Brighton City Council Meeting

SUBJECT: CONSIDER APPROVAL OF SITE PLAN 26-01, A BUILDING AND SITE REDEVELOPMENT OF 8355 W GRAND RIVER

**Re: Quench Gas Station
Site Plan Review No. 2**

SUBJECT: Quench Gas Station – Site Plan Review #2 (Revised 2/25/26)

UTILITY PLAN

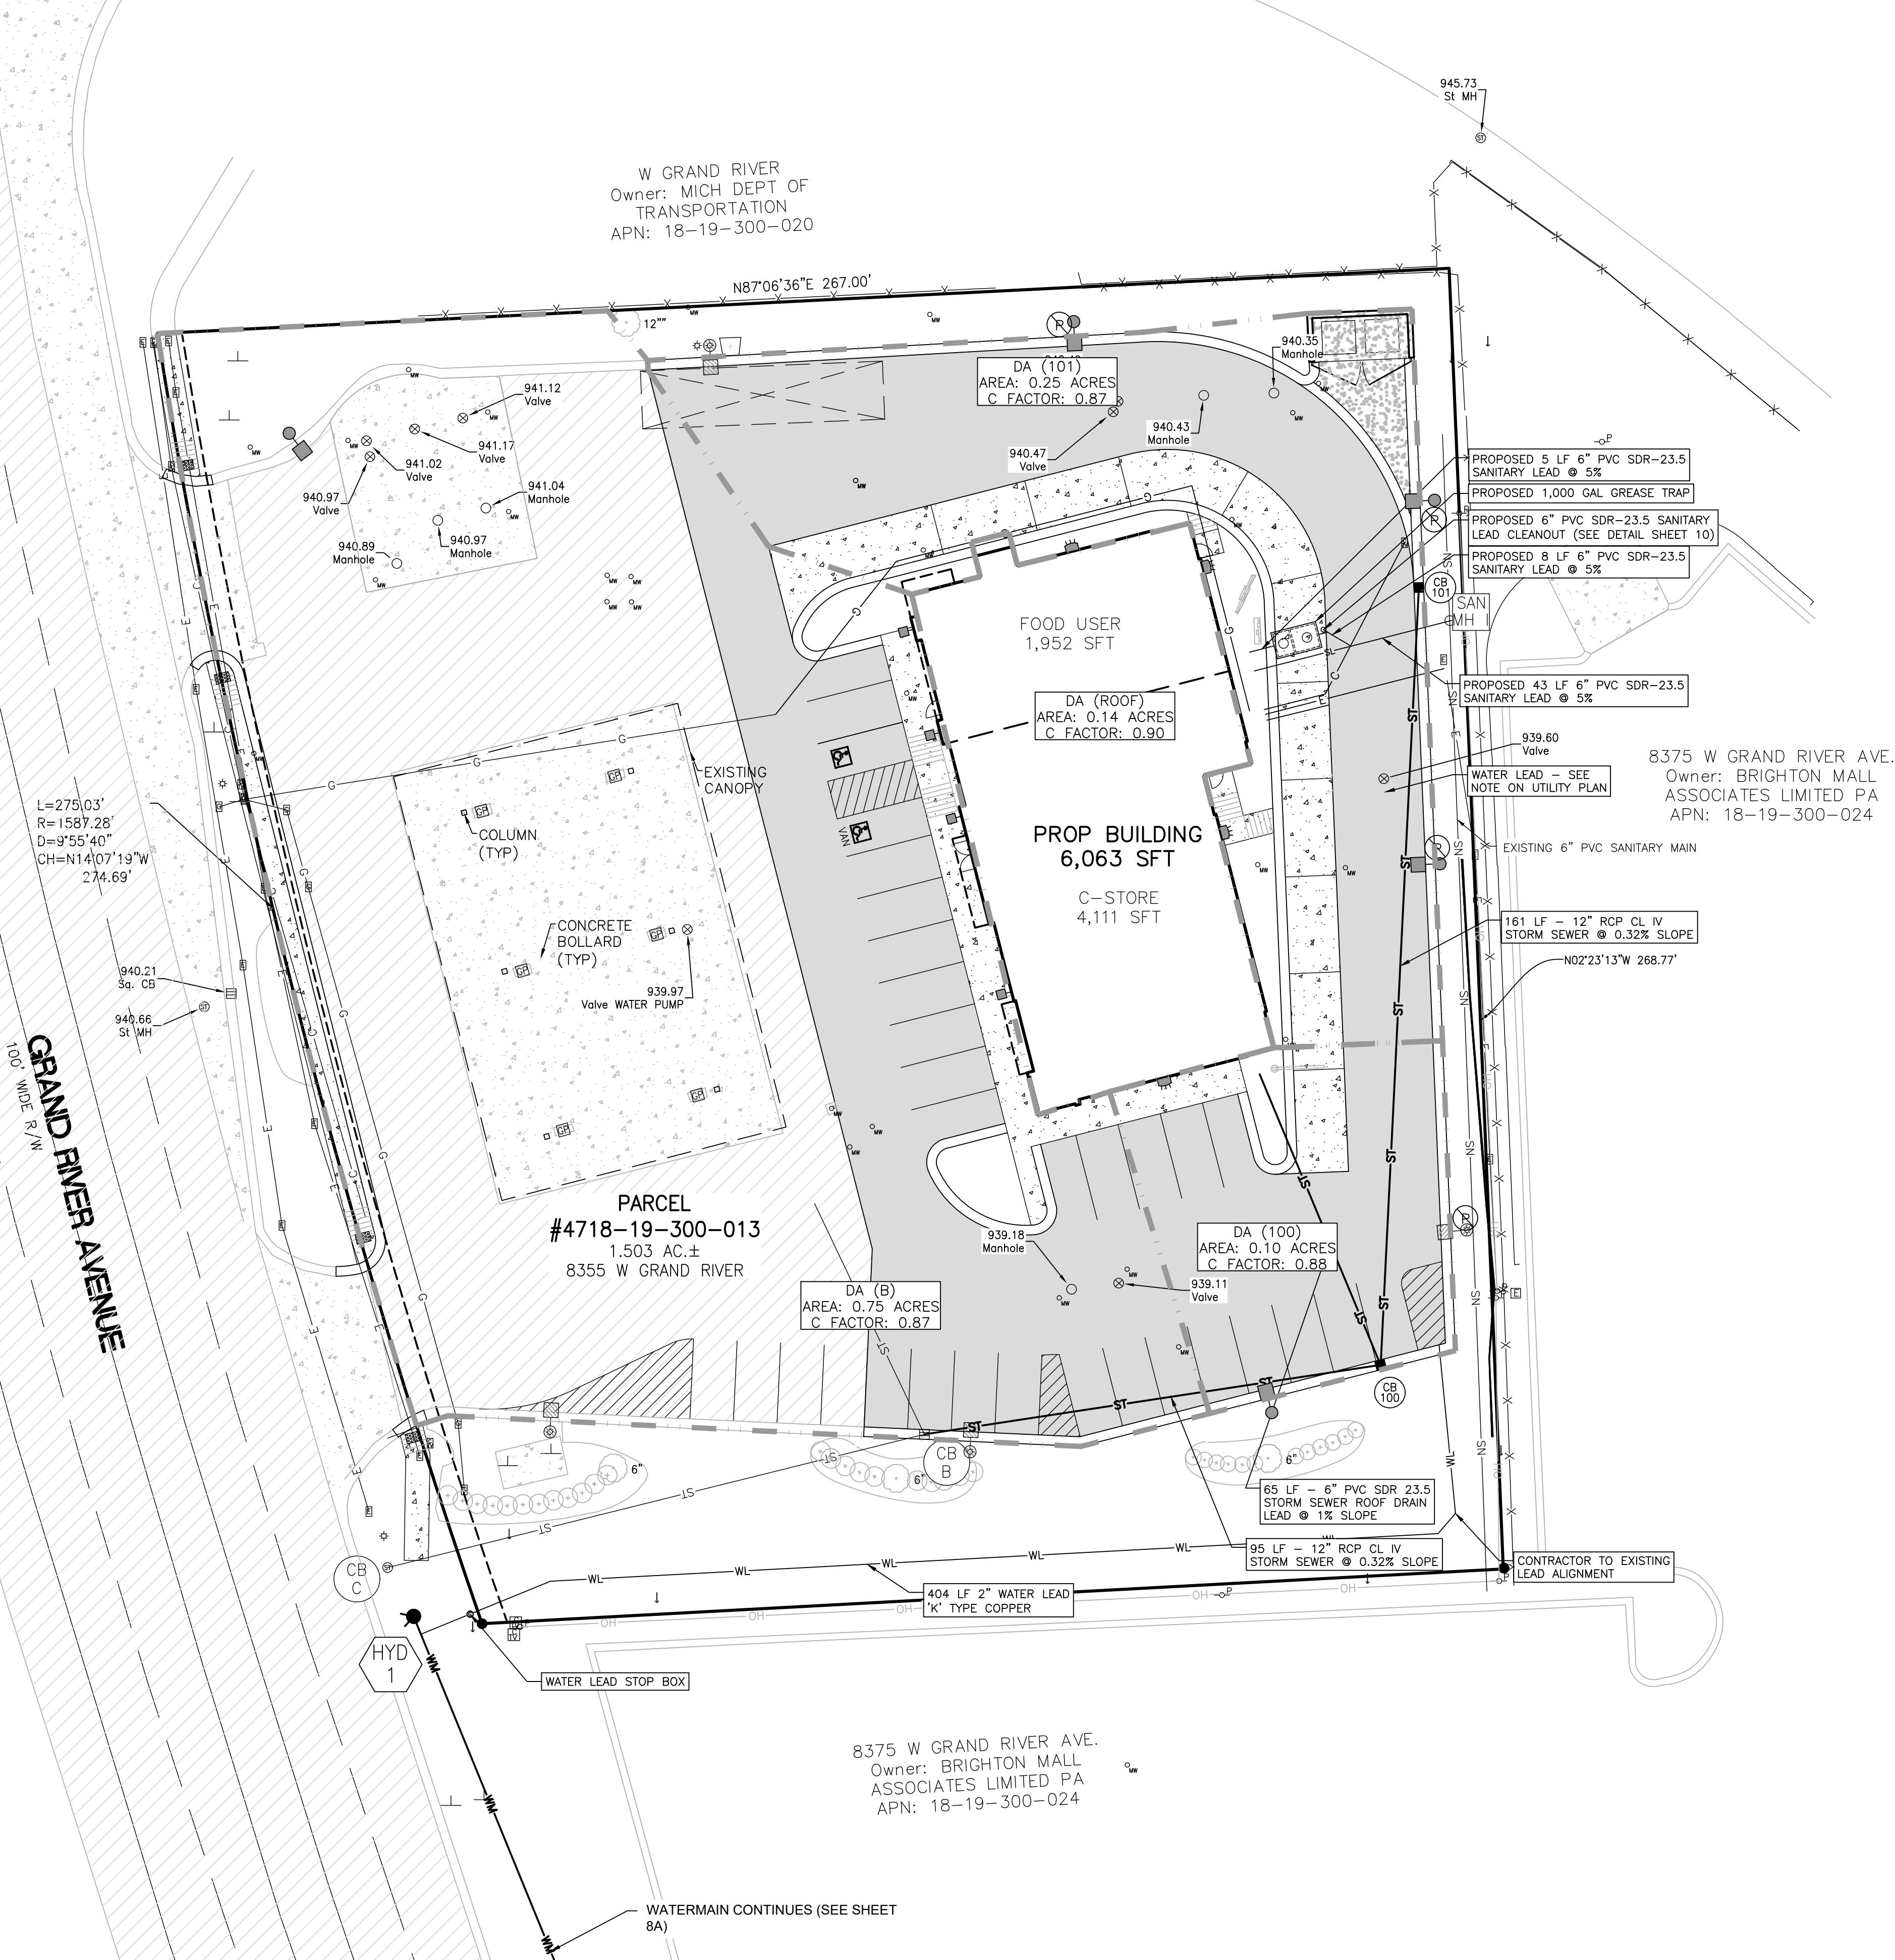
The proposed public water main extension to a new fire hydrant on the southwest corner of the site will require construction plan review and EGLE permitting after site plan approval. The proposed HDPE pipe may need to be upsized to 10-inch diameter to match the inside diameter of an 8-inch DIP pipe.

1. A cleanout on the sanitary lead downstream of the grease tank has been added on sheet 8. A detail for the sanitary cleanout has been added to sheet 10.
2. The existing sanitary main along the east side of the property has been labeled as an existing 6" PVC main (see sheet 4 & 8).
